Response to Document No. E1

Iberdrola Renewables, on behalf of Tule Wind, LLC (Jeffrey Durocher) **Dated March 4, 2011**

FIGURE E1-1

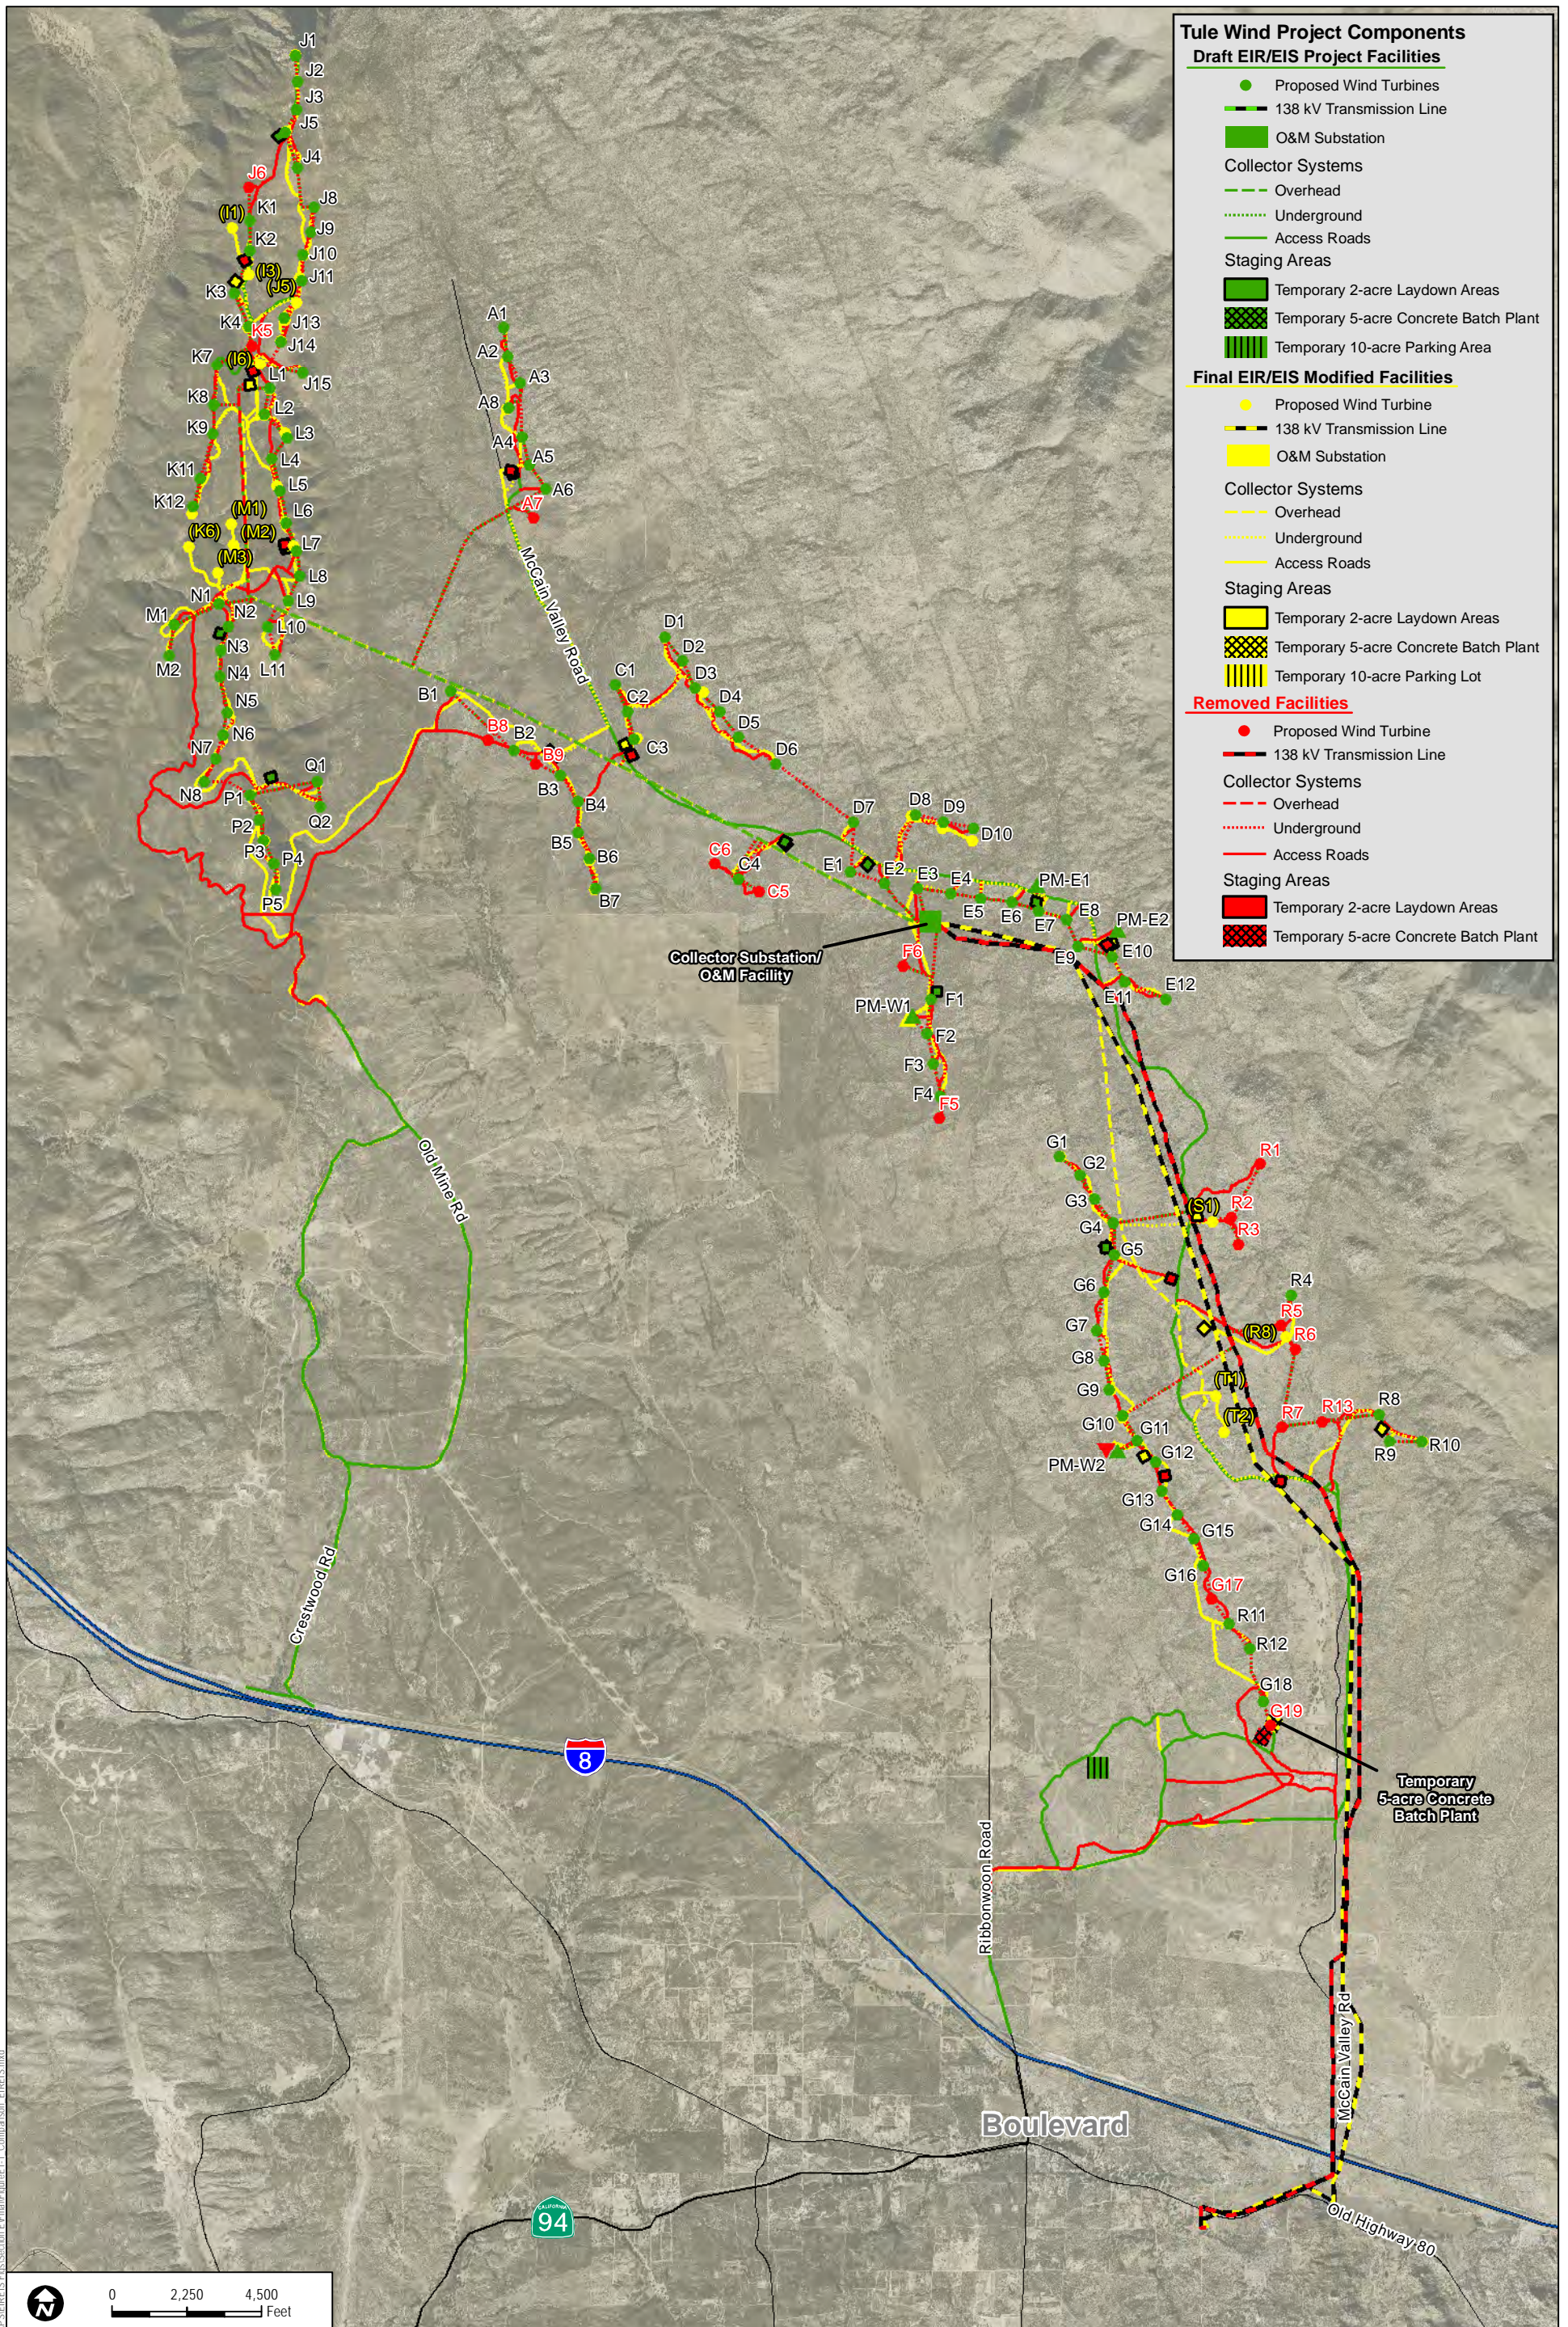
Table 1 and Figure E1-1 provide a comparison of the Tule Wind Project analyzed in the Draft EIR/EIS with the Tule Wind modified project as provided in this comment letter. As demonstrated by Table 1 and Figure E1-1, the proposed modifications are minor and these changes and additions to the Final EIR/EIS are not considered to be substantial relevant to environmental concerns.
